1. New Primary School in Mulgoa Rise – 1-23 Forestwood Drive – Glenmore Park

ptc. has been engaged by Richard Crookes Construction on behalf of School Infrastructure NSW (SINSW) to address comments received following the submission of the State Significant Development Application (SSDA) and subsequent additional request for information for the proposed development of a new primary school located at 1-23 Forestwood Drive in Glenmore Park.

This letter has been prepared in response to the following documents:

- Letter dated 3 December 2021 from Penrith City Council (Council),
- Letter dated 8 December 2021 from Transport for NSW (TfNSW),
- Letter dated 18 December 2021 from the Department for Planning, Industry & Environment.

Figure 1 – Proposed Zebra Crossing Design

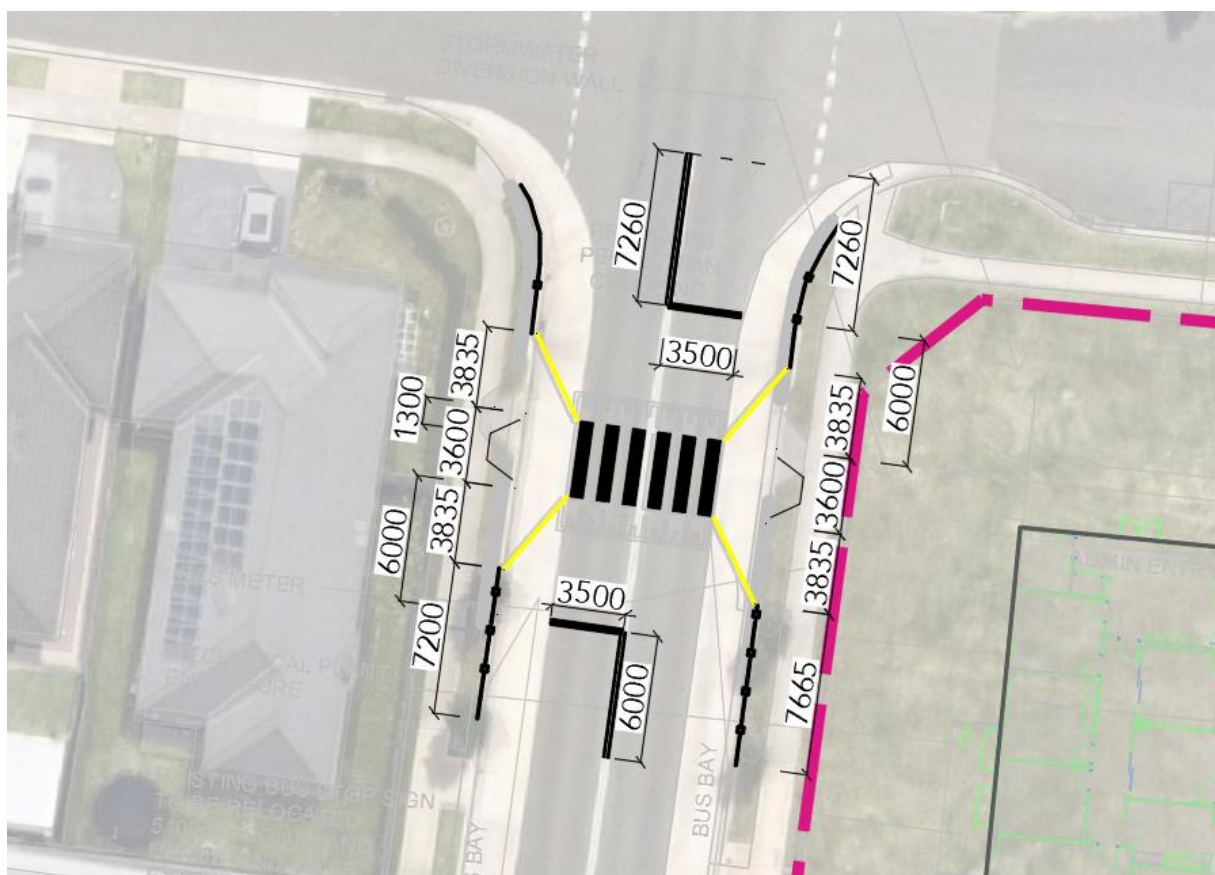
- *The proposal for pedestrian crossings to be at-grade rather than raised "wombat" style crossings,*

As per advice received from the project's civil engineer, blisters or raised crossings are not feasible due to potential flooding issues, please refer to the flooding assessment. The proposed solution is shown in Figure 1, with yellow lines representing fencing instead of kerb buildouts. The project is open to alternatives, such as bollards or other devices if these are seen as a better outcome. Refer to Section 3.1 for further comments and analysis.

Figure 5 – Proposed zebra crossing design

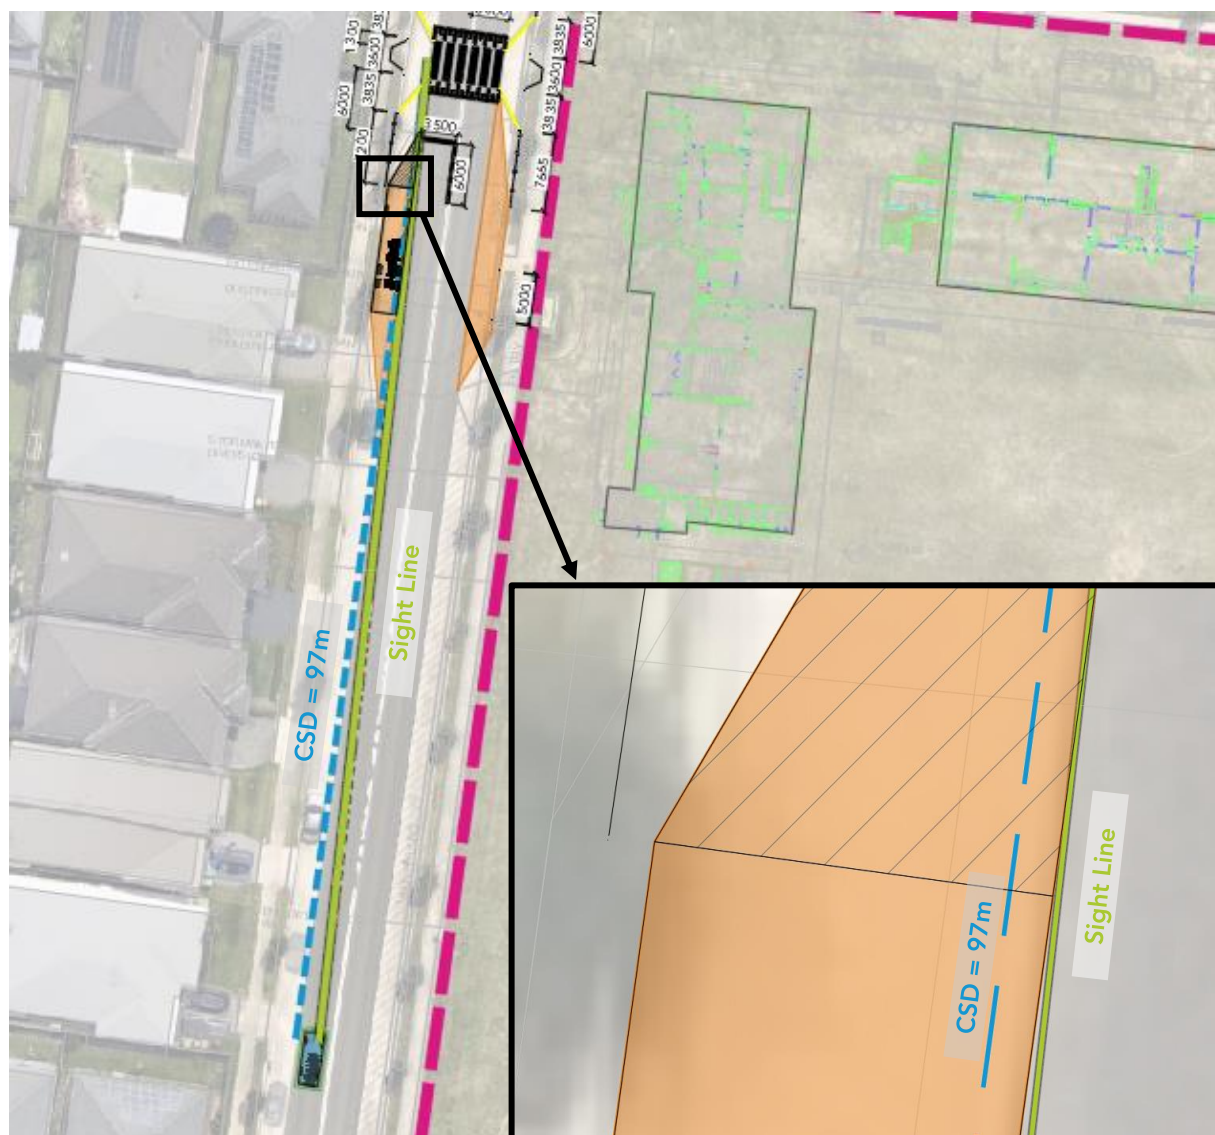
a) the provided plan on figure 6 does not show an outline of a bus in bus zone and it is not indicative of whether the sight line encroaches the orange area (bus zone) e.g. is the green line actually overlapping the orange shape? CSD is measured from behind the kerb and not at the face of the crossing/kerb as shown in Figure 3.7 of AGRD Part 4A. It is requested that a more detailed/indicative plan is provided. It is also noted that the proposed design (as per figure 6) is not supported. Any sort of blister island device is also not a kerb extension, but rather a 'splinter island', and so the 'No Stopping' distance and CSD should be measured from the kerb ramp as the zebra crossing would need to extend from kerb to kerb, not where the blister ends;

The sight distance figure has been amended as per TfNSW comment and is shown below, with the bus parked in the bus bay and a vehicle approaching the zebra crossing. The figure shows that the sight line is outside of the bus parked in the bus bay.

It is noted that the bus zone will be mostly unoccupied, with buses expected to stop at this bus stop no more than 2-3 time within one hour.

Figure 7 – Bus Bays at Darug Avenue

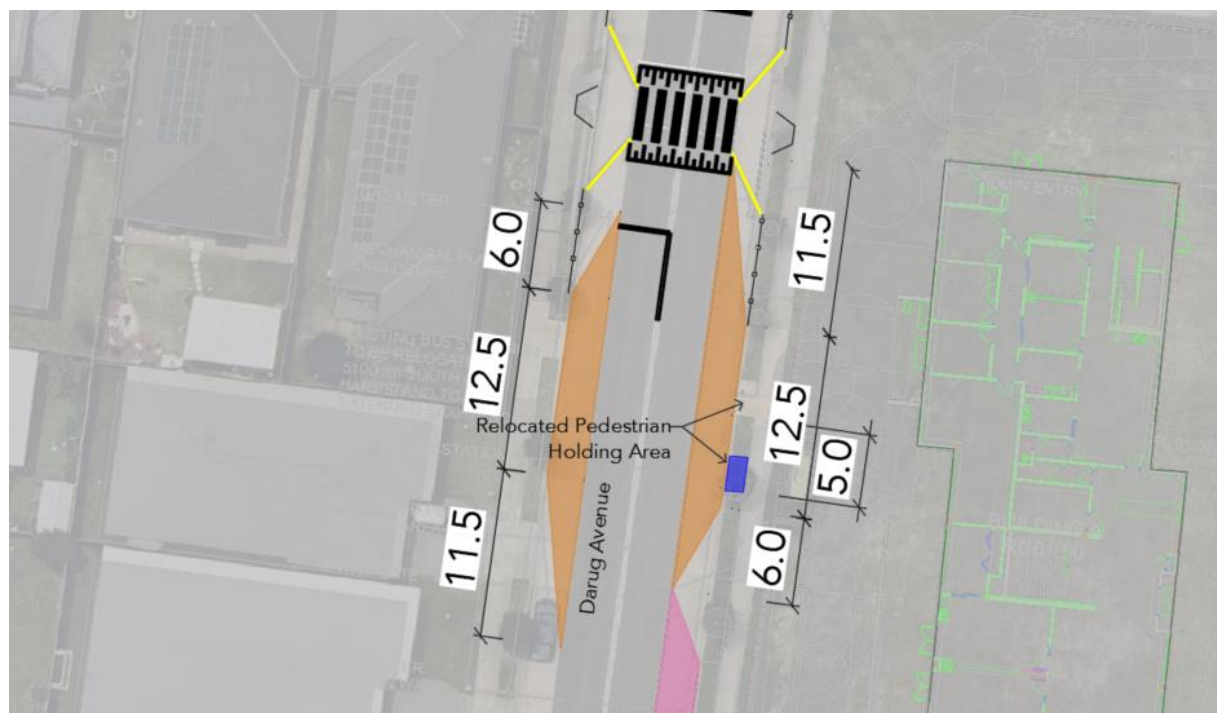
In addition, the bus bay is to have sufficient length (consider draw-in length, draw out length, and maximum number of services expected at any one time) to ensure that buses can be fully contained within bus bay;

The proposed zebra crossing and the proposed relocated eastern bus bay have been located such that both bus bays at Darug Avenue will be compliant with the TfNSW requirement, thus will meet the minimum requirement for parking, draw-in and draw-out lengths, as shown in Figure 7.

Figure 8 – Proposed Zebra Crossing Design

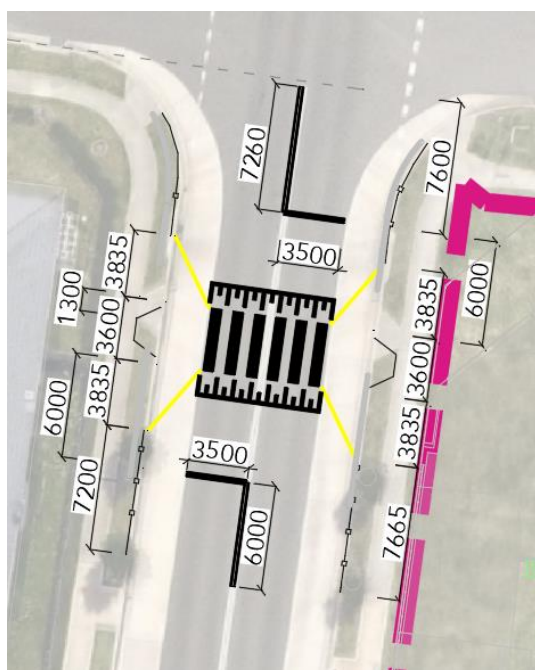
6.4.1 & Attachment 2 (Pedestrian Crossings) – The Crossings need to be designed in accordance with relevant standards, guidelines and supplements. Fencing is not an approved device as part of a zebra crossing. It should be noted that fencing at crossings can obscure visibility of pedestrians (in particular children shorter in height than the fencing). Therefore this design will not be supported by TfNSW;

- a. *Figure 1 (and all other figures containing the crossing) should be updated to reflect the design in Attachment 1;*
- b. *Can it be confirmed whether Attachment 1 is the amended crossing design? There is conflicting information and plans contained within the letter that suggests any raised infrastructure causes flooding issues, yet Attachment 1 appears to suggest a 'blister island';*
- c. *Attachment 1 –*
 - i. *At-grade zebra crossings do not require piano key pavement marking (these are used for raised crossings);*
 - ii. *Fencing indicated by the 'yellow line' is not an approved device and should not be installed in such a manner. Proposed RMS type 1 Pedestrian fencing on kerb can be extended further to meet at crossing point;*
 - iii. *Is it proposed to have a kerb ramp where there is a grate across the gutter? This is not clear, please clarify.*

A revised at grade zebra crossing design is shown in the below figure and in Attachment 1, with the yellow lines representing fencing (or any other structure i.e. bollards that would be deemed acceptable) to imitate the kerb buildouts. This is so that the impact on the water flow within the carriageway is minimised.

The change in pavement and line marking were proposed to imitate a raised crossing / shared zone, thus to raise driver's awareness of an increased pedestrian activity. This is because the development cannot provide a raised zebra crossing due to flooding issues. However, the piano keys can be removed.

Figure 11 – Unobstructed sight lines to the Darug Avenue zebra crossing and the stop line

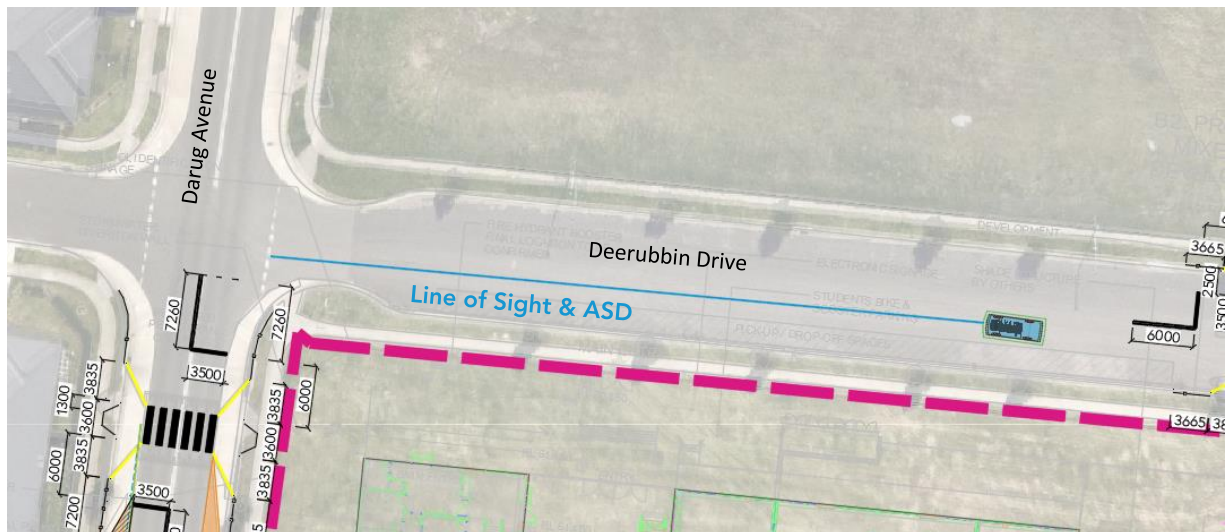
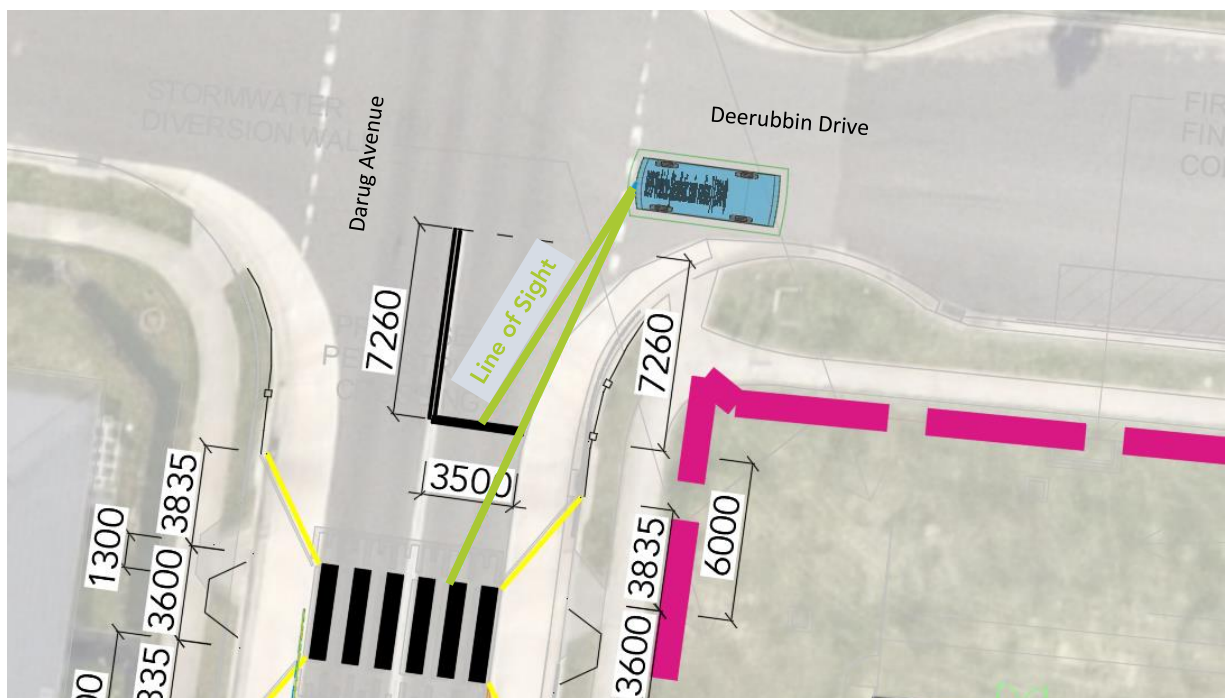
- a. *It is considered that the proposed children crossing location does not provide sufficient sight distance for vehicles travelling south (turning from Deerubbin Drive). Despite having sufficient space to provide the stop line 6 metres from the crossing, and having 7.26 metres of storage, this does not account for the approach sight distance required for drivers turning from Deerubbin Drive to observe the stop line and other associated cues of the children’s crossing (see AGRD Part 4a – section 3.3). Provision of ASD ensures that even if there is no pedestrian actually on the crossing, the driver should be aware of the crossing by seeing the associated pavement markings and other cues, and therefore be alerted to take the appropriate action if a pedestrian steps onto the crossing. Provision of ASD should be used for crossings where the pedestrian has the priority;*

- i. *Note that ASD should be calculated from where the turning manoeuvre is complete, and not from the holding line of the minor leg at the intersection.*

Deerubbin Drive is the minor road approaching the major road – Darug Avenue. Given that the section of Deerubbin Drive is straight, it is considered that the ASD is met for this intersection in the sense of the definition provided above. Refer to Figure 10 for the ASD at the subject intersection.

The guideline does not appear to stipulate that the ASD applies to facilities, i.e. zebra crossings, located around the corner of the minor road approach, noting that vehicles are legally required to slow down and be prepared to stop at the “Give Way” line to assess the adequacy of further travel movement. Once at the intersection, vehicles would have an unobstructed sight line onto the zebra crossing, approaching pedestrians and the stop line, as shown in Figure 11.

Figure 16 – HRV Swept Path at proposed Zebra Crossing at Forestwood Drive

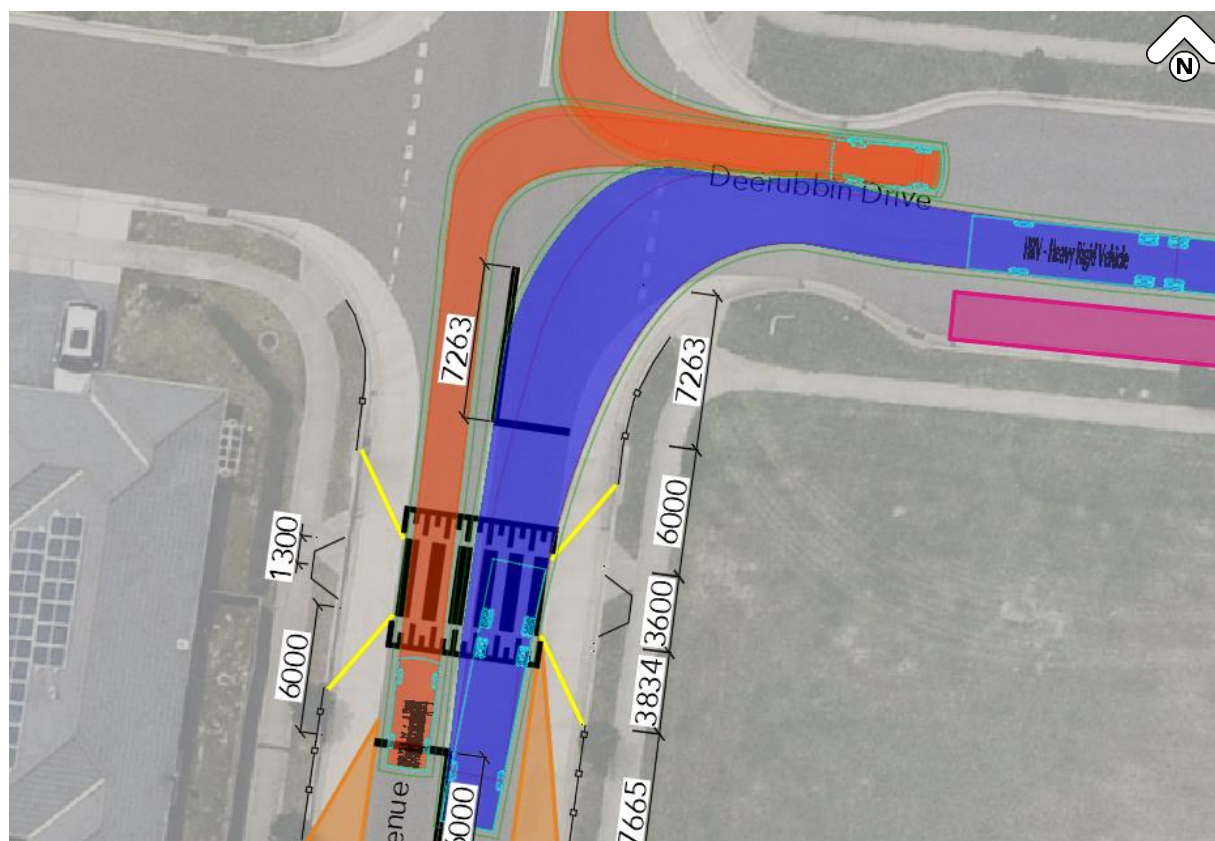
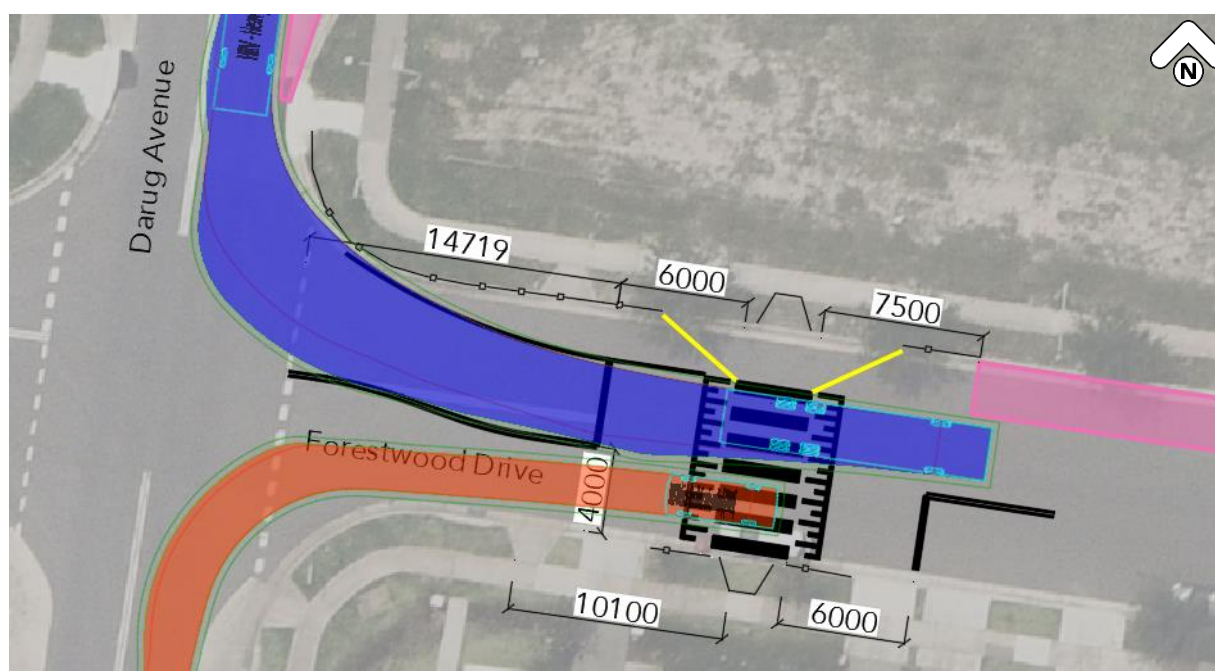
Figure 56 & Attachment 2 (Pedestrian Crossings) – The swept path is considered unacceptable (particularly due to the proximity to the pedestrian crossing), the plans indicate that a HRV encroaches over the centreline into the opposing traffic lane on both Darug Avenue and Forestwood Drive. This would result in a B99 vehicle travelling along Forestwood Drive to be forced to occupy the very left of the carriageway which is unrealistic if the vehicle is wishing to travel straight or turn right (and arrives before the HRV);

The proposed zebra crossing at Darug Avenue has been relocated further south and is located at 13.3m south of Darug Avenue / Deerubbin Drive intersection. The HRV turn movement swept path has been re-run and it can be accommodated without crossing the opposite lane, as shown in Figure 16.

The proposed zebra crossing location at Forestwood Drive has been relocated further east at 20.7m from the Darug Avenue / Forestwood Drive intersection. The proposed new location allows for adequate turn movement as shown in Figure 17.

Figure 21 - Surveyors Creek Public School – 552 Students

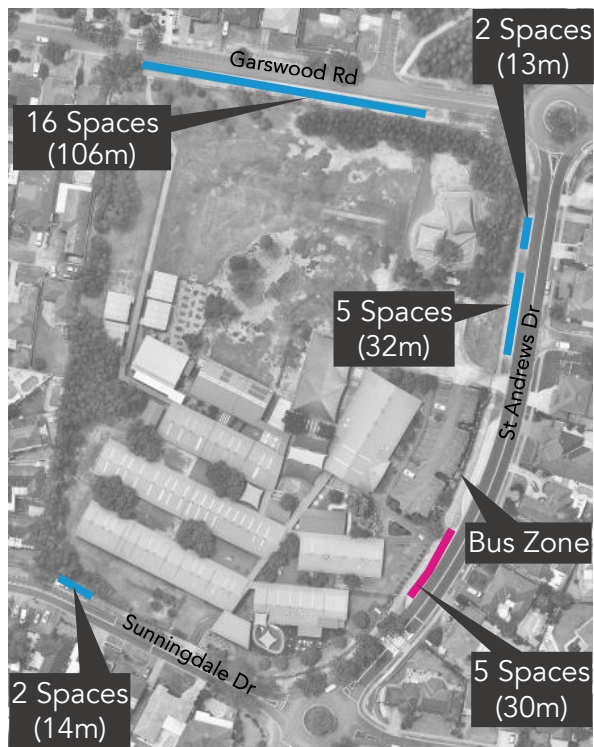
Requests from the Department, Council and TfNSW to provide comparisons of the mode share performance at local schools with similar characteristics to demonstrate that mode share targets can be achieved was not adequately addressed in the RtS. The RtS outlines new processes SINSW has implemented for school developments to investigate measures to increase active and public transport usage and the percentage of students in the 400m, 800m and 1,200m catchments but does not provide a comparison of travel modes at other local schools (including Glenmore Park Public School and Surveyors Creek Public School).

A detailed comparison of the mode usage at local primary schools must be provided to demonstrate that the proposed mode breakdown outlined in the School Transport Plan may be achieved.

In order to provide a comparison of the drop-off and pick-up availability, an assessment has been undertaken of the quantity of drop-off and pick-up spaces along the frontage roads at the surrounding schools. These are presented in Figure 19, Figure 20, Figure 21 and Figure 22.
